DEVIATION REQUEST (Attach diagrams, figures, and other documentation to clarify request)

A deviation from the standards of or in Appendix F, Standard Drawings, **SD 4-4, Urban Residential Collector** and **Table 2-7. Roadway Design Standards for Urban Collectors and Locals**- of the Engineering Criteria Manual (ECM) is requested.

A deviation from the standard Urban Residential Collector Roadway Cross Section for Southern Rail Point, Pacific Rail Point, and Central Rail Point is requested. The standard cross section includes two travel lanes (12') and two shoulders (6') within a 36-foot wide pavement mat; two 2.5-foot curb and gutter at the end of the pavement mat; two four (4) foot (typical) landscape/tree lawns; two five (5) foot detached sidewalks all within a 60-foot ROW.

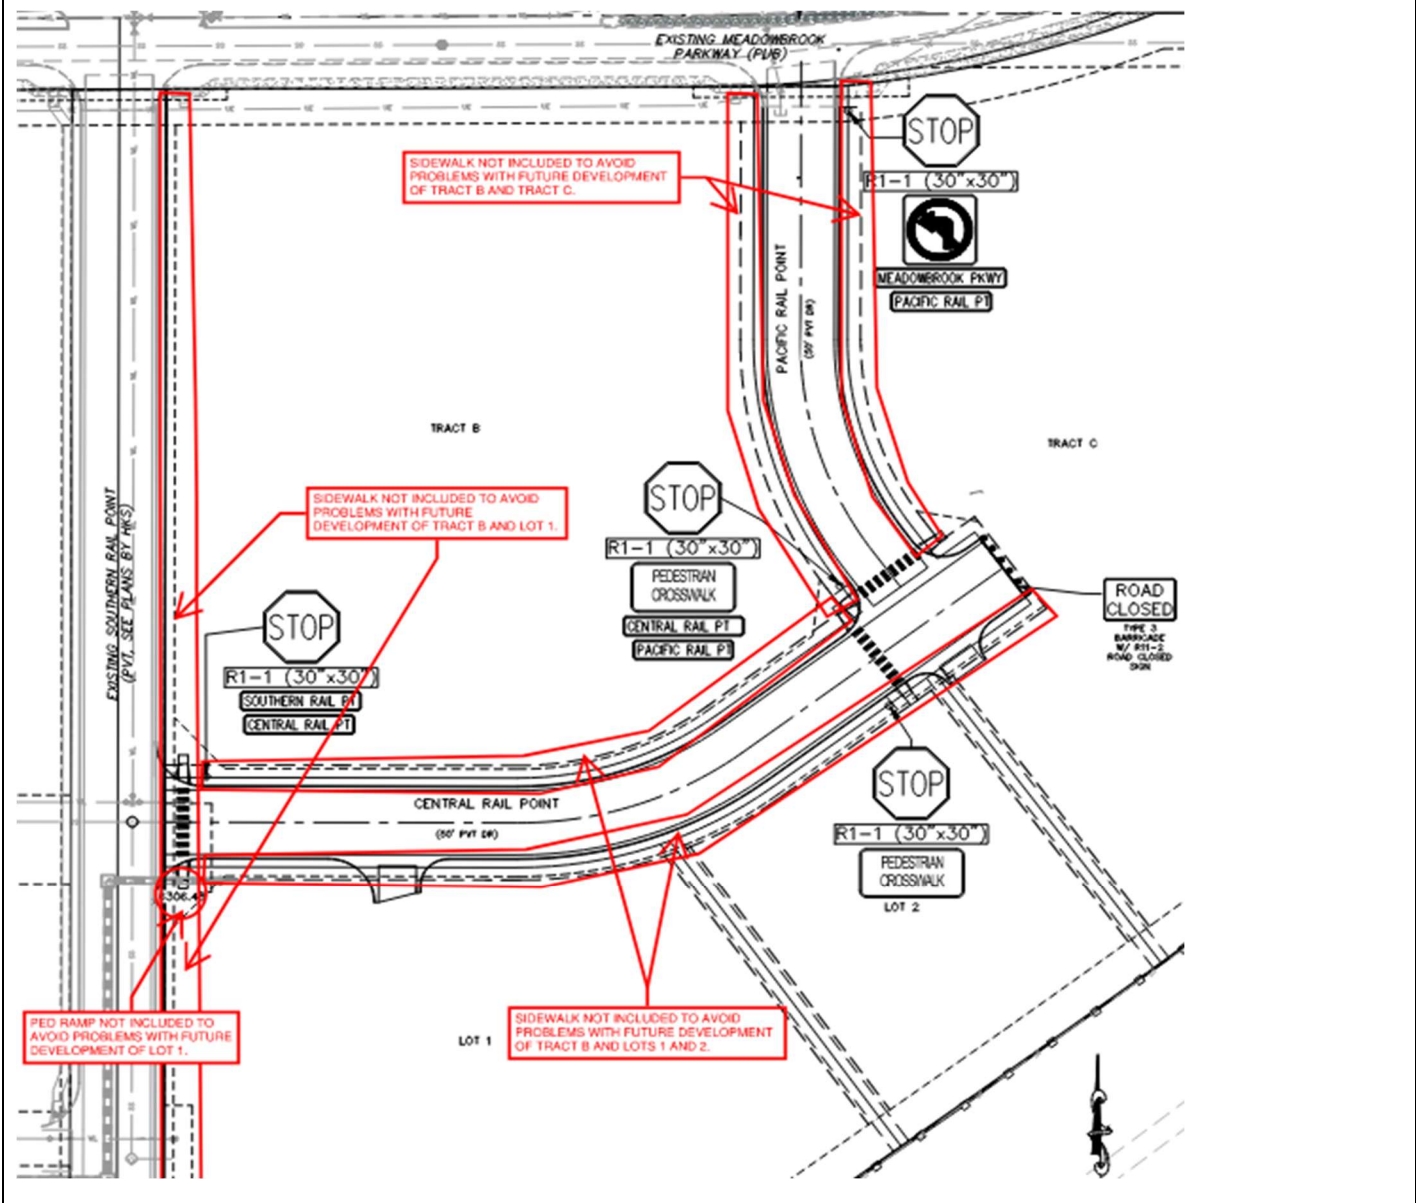
The proposed private road cross section includes the following deviation(s) from standard ECM Standards for an urban residential collector section. Requesting;

- 50-foot tract dedicated for private road and utility use. Typical cross section is within a 60-foot Public ROW.
- 36 foot pavement width, where typical cross section has a 36' pavement width. No Change.

- Two 12-foot travel lanes with two 6' shoulders, where typical cross section has two 12-foot travel lanes with two 6' shoulders. No Change.
- 40 MPH design speed/35 MPH posted speed, where typical cross section has 40 MPH design speed/35 MPH posted speed. No Change.

- 5-foot detached sidewalk on one side, where typical cross section has 5' detached sidewalks on both sides. The sidewalk is outside of the 50-foot tract. An additional 5 foot Public Access Utility Easement has been provided to accommodate the portion of sidewalk lying outside the tract. Only one side of the roadways are proposed to have an attached sidewalk. Several sidewalks and ADA Ped Ramps are not proposed with Filing No. 2 in the specified areas (outlined in red) because they may cause problems with future development and driveway cuts.
